4. Zoning By-law Amendment – 116 York Street
Modification du *Règlement de zonage* – 116, rue York

File Number: ACS2020-PIE-PS-0004

SUBJECT: Zoning By-law Amendment – 116 York Street

Figure 1: Excerpt of Schedule 74 showing maximum building heights.

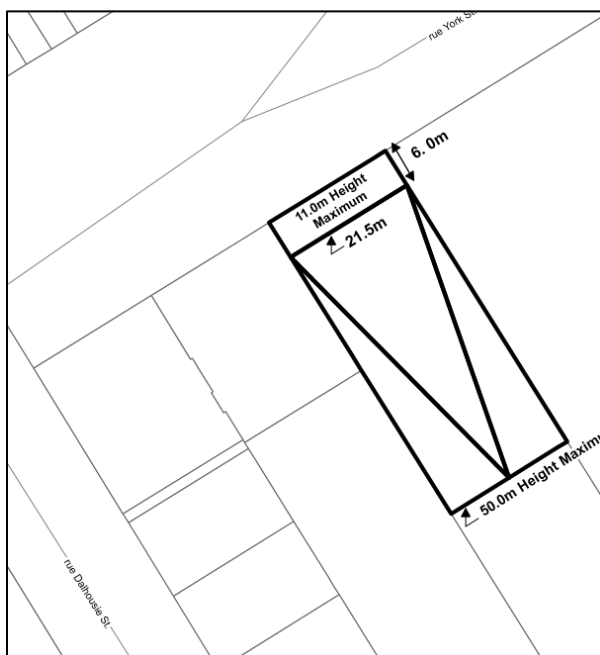
- Concern that the proposal violates the angular plane.
- Concern about setting precedent for high rise in ByWard Market.
- Setbacks are dismissed because they add complexity and costs to construction.
- The adjacent Andaz Hotel is 16 storey – and not 15 stories as noted in the Application Summary and Planning Rationale.
- Five-storey buildings should be the new minimum, in and directly around the Market.
- The existing heights permitted by Schedule 74 should be more than sufficient. The transitioning feature with an angular plane would make for an interesting design.
- A disappointing example of height and bulkiness is the Andaz Hotel. It is so much higher than the nearby buildings, creating a visual disharmony.
- Lot is too narrow for a high-rise building.

Through the rationale of this report, staff have expressed their concern with the proposed height at this location.

Document 2 (a) – Proposed Development: York Street Elevation

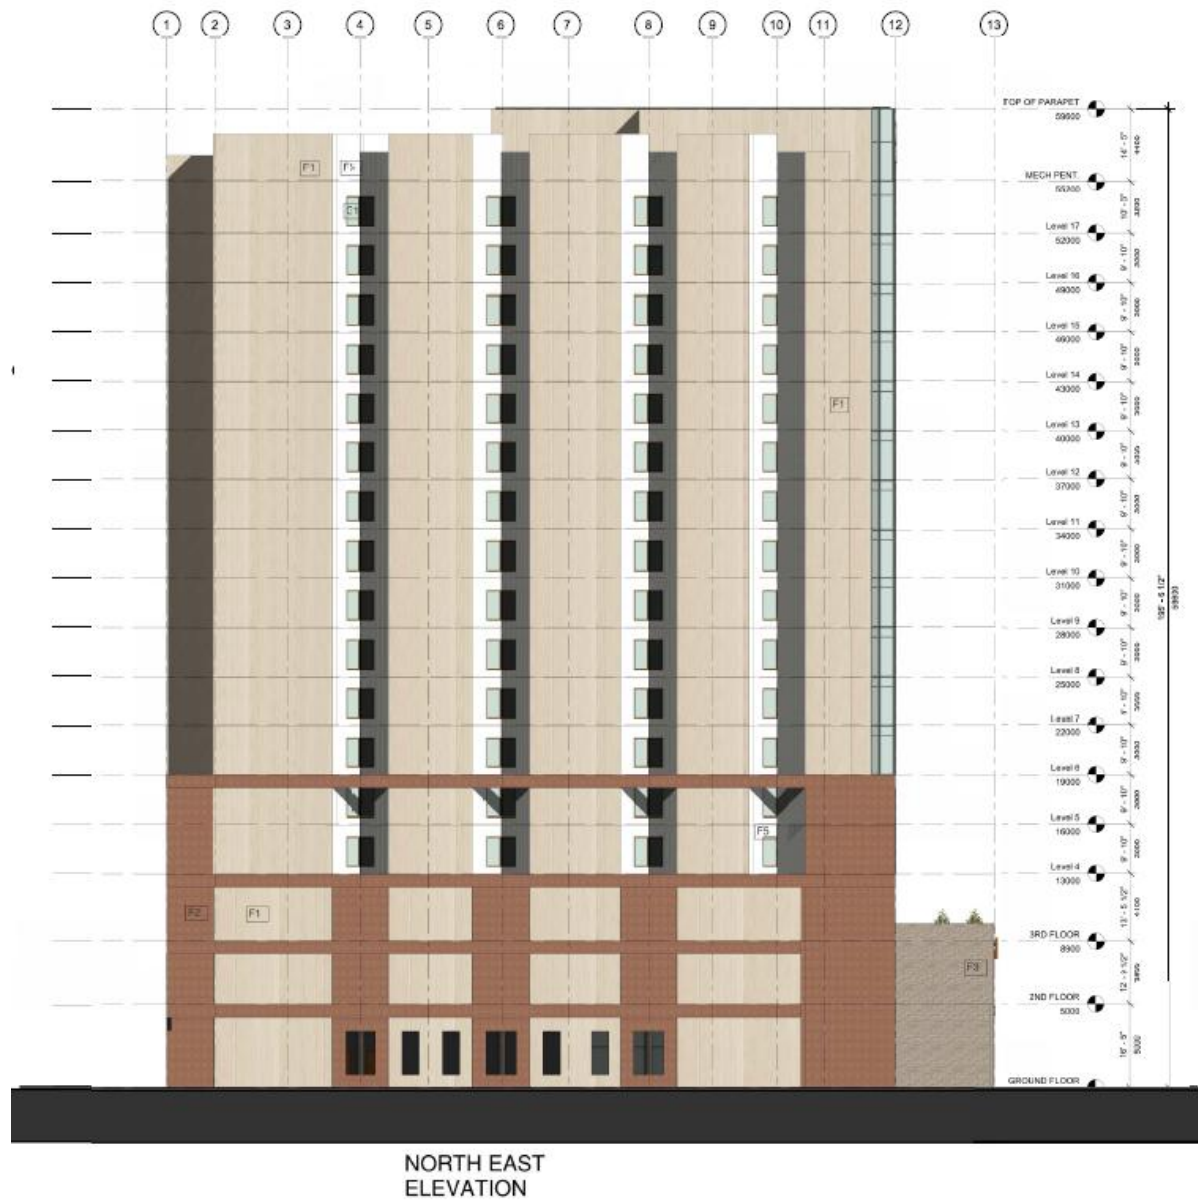
Firstly, the proposal does not meet the overall intent and vision for the Central Area policies described in Section 3.6.6 of the Official Plan. York Street is identified in the plan as an entrance to and promenade through the ByWard Market with a significant heritage character. The sun shadow study submitted with the application shows how the proposed height of the building will create new shadows along York Street, adversely affecting pedestrian comfort and heritage character along this key corridor. The wide loading and parking garage entrance along York Street is a predominant ground floor feature of the proposal that will not provide animation to the street and will diminish the City's vision for York Street as a pedestrian promenade.

Moreover, the transition from low-rise podium to high-rise tower is not successful. Accepting that the south elevation of the tower will attain a height of 50.0 metres, in no circumstance should the tower portion rise as a singular extruded mass. Articulation and progressive stepping back is required to provide visual relief and to minimize the effect of height. Relief from the angular plane provision should therefore not be granted.

Document 3 – Proposed Ground Floor Plan

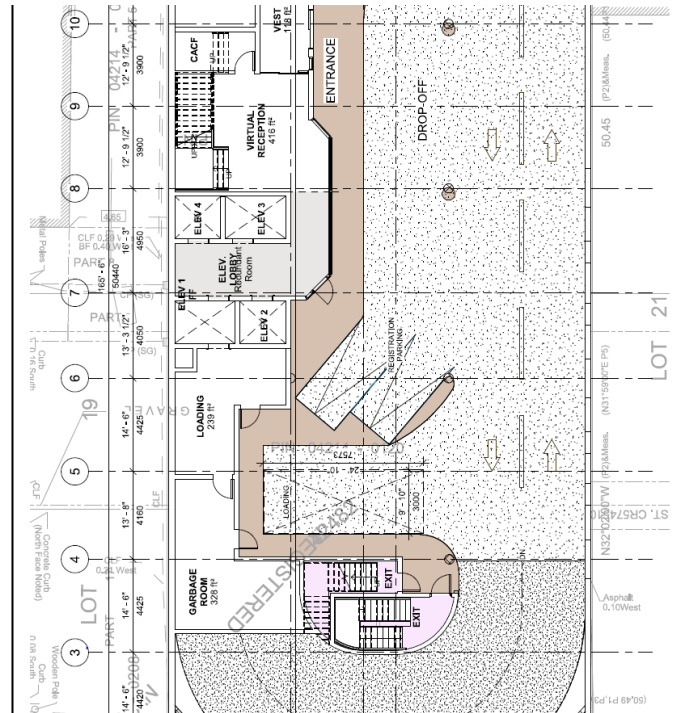
- The hotel will have large amounts of maintenance and supplies providers. With only one loading space, that will be a problem.

Staff are concerned with the location of the proposed loading space. Staff would prefer that the owner coordinate with adjacent property owners to share loading facilities and eliminate the driveway along York Street.
